Bonnyknox Solar Farm Addendum Report

Application Site: Bonnyknox Solar Farm

Document Ref: 313625/010726/BT/2.0

Issue-2.0

Image 1.1 – Previously Submitted Watercrossing as per expired Drawing Number 05114-RES-LAY-DR-PT-003 (Rev 4)

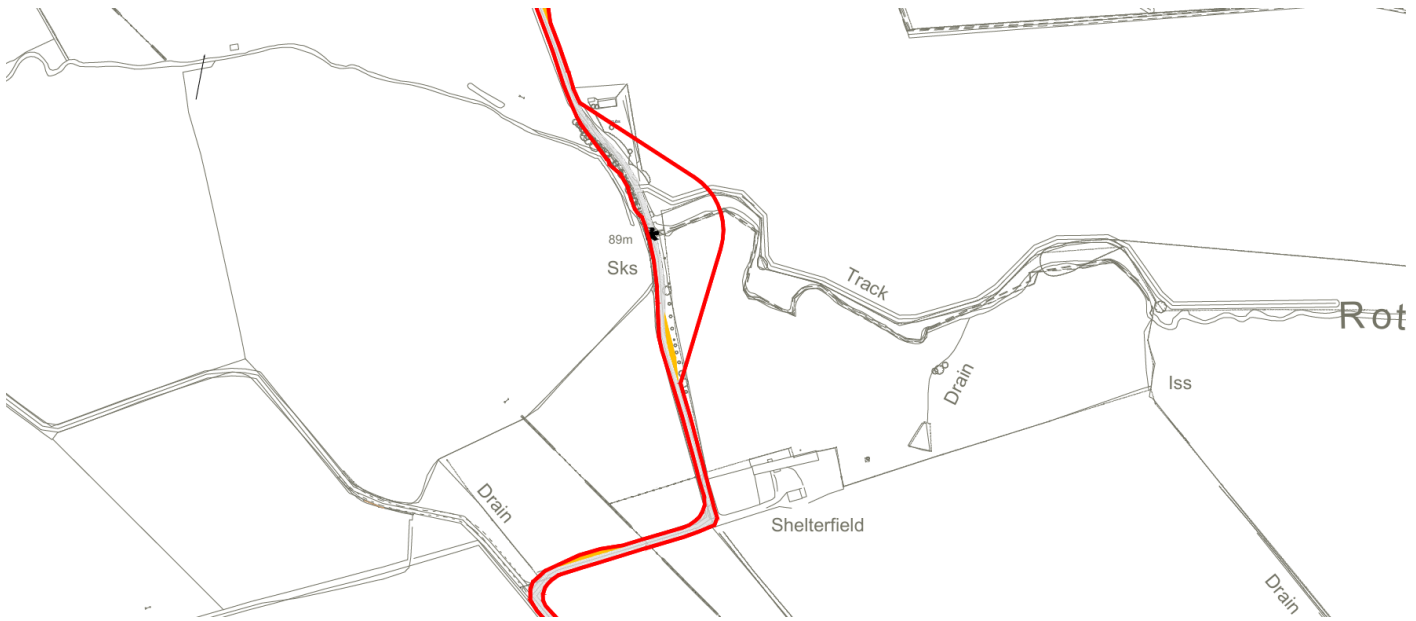
1.2.1 Following the conclusion of discussions with a third-party landowner, the Applicant has removed the proposed water crossing over Rottenraw Burn, as it is no longer required to access the Proposed Development. Please refer to Images 1.1 and 1.2 below, which confirm the amendments to this area.

Image 1.2 – Removal of Watercrossing as per latest Drawing Number 05114-RES-LAY-DR-PT-003 (Rev 8)
